FINAL PLAT
BROCK THIRD ADDITION
TO
WICHITA
SEDGWICK COUNTY, KANSAS

Re: S/D 97-22 - BROCK 3RD ADDITION (Final Plat)

Re: S/D 97-22 - BROCK 3RD ADDITION (Final Plat)

CASE NUMBER: S/D 97-22 - BROCK 3RD ADDITION

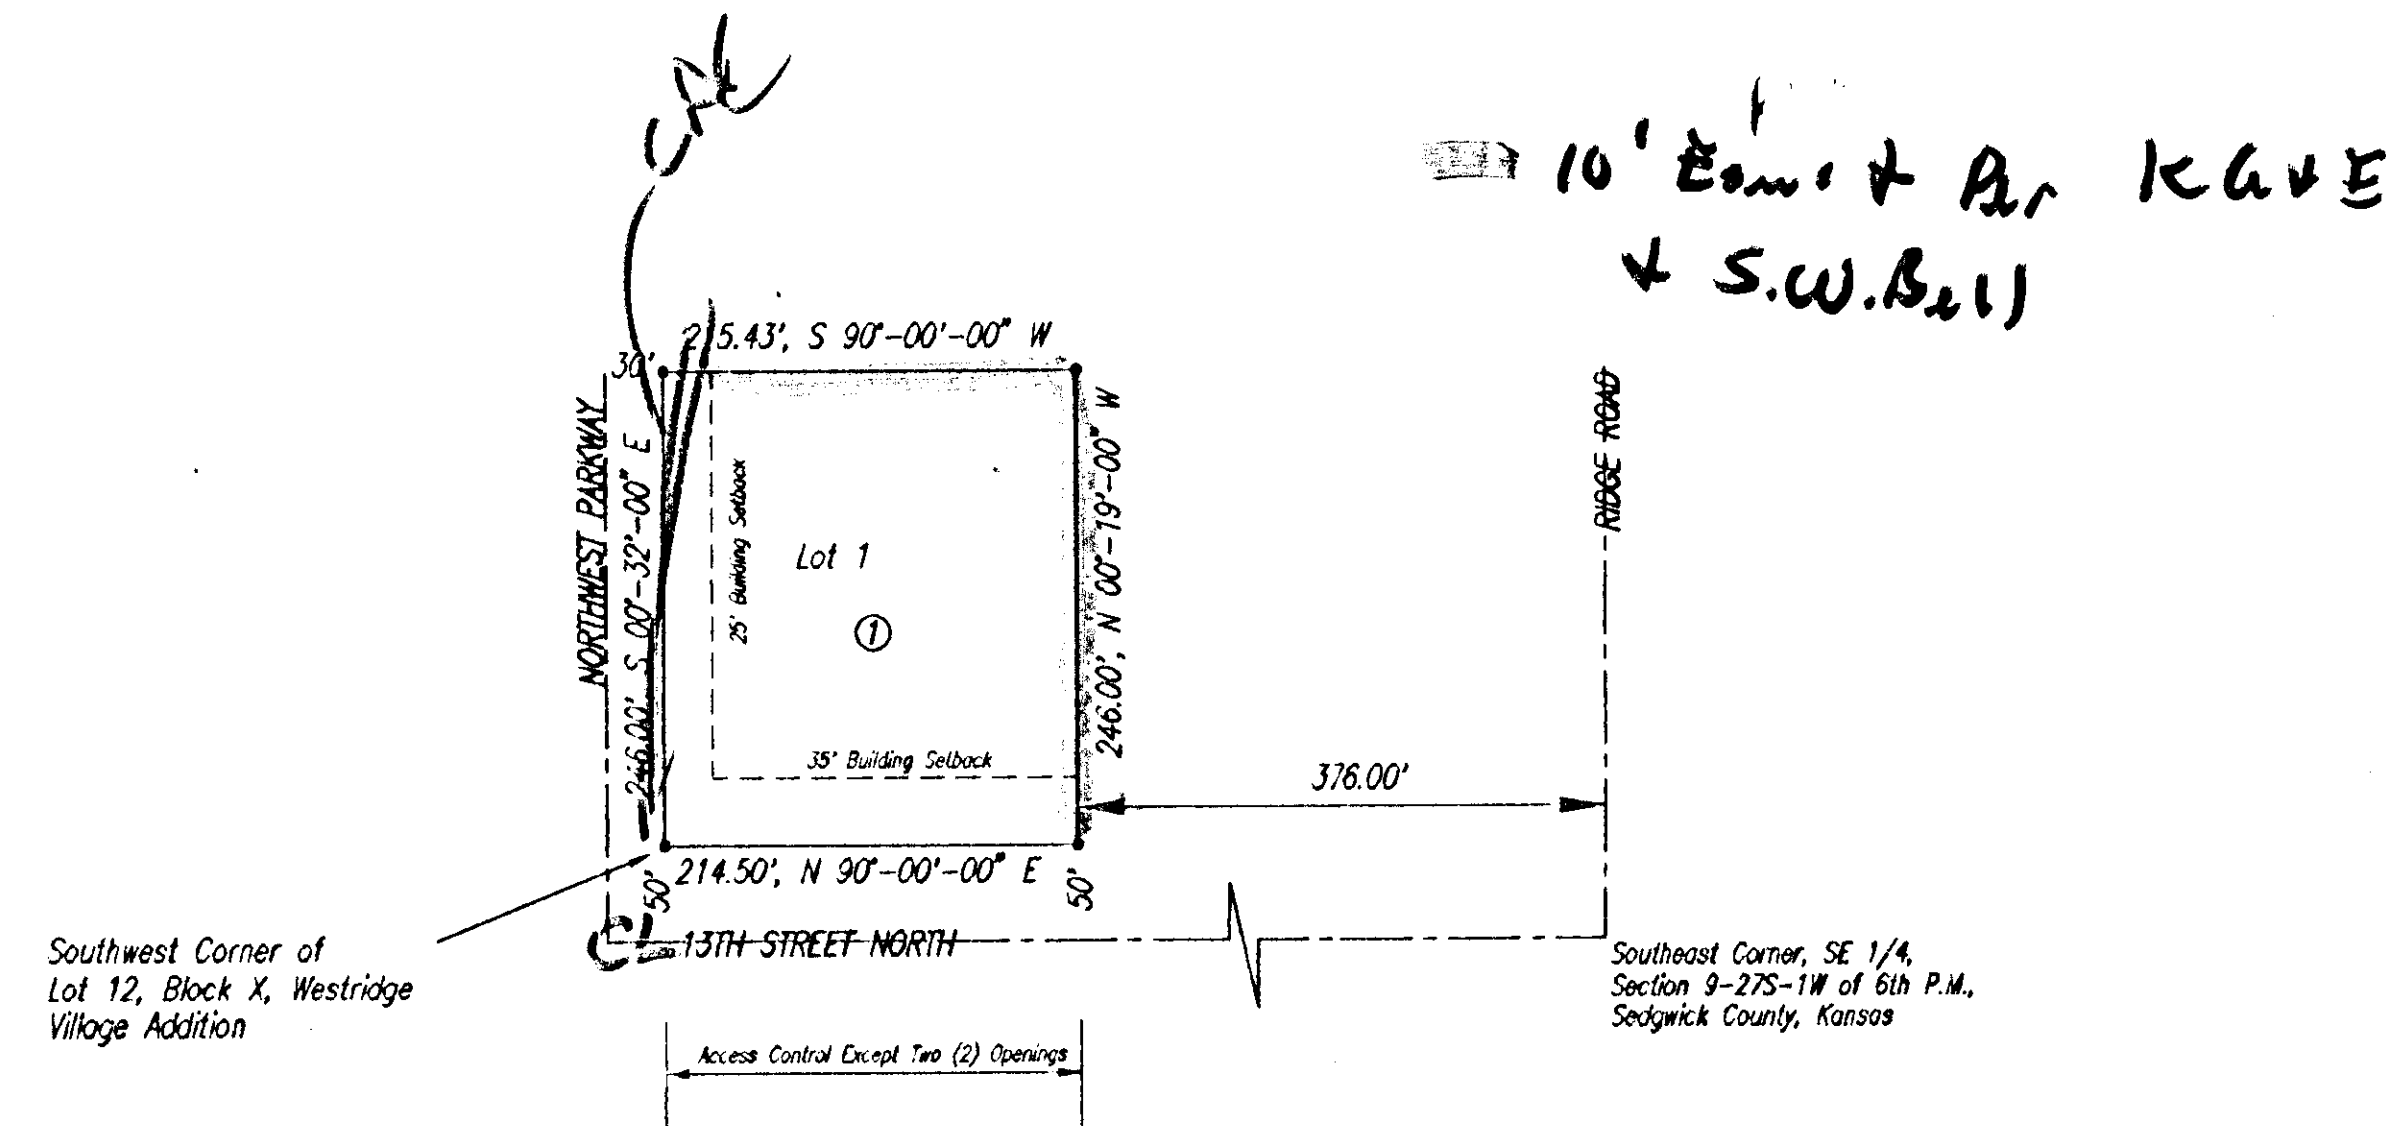
- C. On the final plat tracing, complete access control shall be indicated to Northwest Parkway on the face of the plat. The plat's text shall also be amended to note this dedication, but also shall be revised to use the standard terminology for the dedication of access controls to the City and the approval of opening locations (13th Street) by the City Engineer.

- D. On the final plat tracing, the owner's signature and title (if any) shall be printed below the plat's signature line. If this ownership is different than now being shown by the platting binder, an updated binder shall also be provided with the final plat tracing.

- E. On the final plat tracing, the Deputy Register of Deeds shall be indicated as Michael D. Hurtt.
- F. If the dot symbols at the corner of this plat (lot) involve irons found, set, etc. this should be noted in a legend located below the north arrow.

- G. On the final plat tracing, the center line of 13th Street North shall be labelled "CL".
- H. The applicant shall install or guarantee the installation of all utilities and facilities which are applicable and described in Article 8 of the MAPC Subdivision Regulations. (Water service and fire hydrants required by Article 8 for fire protection shall be as per the direction and approval of the Chief of the Fire Department.)

- M. The final plat shall indicate the utility easements requested by K.G.& E. and Southwestern Bell which are indicated on the enclosed "marked" copy of the plat.
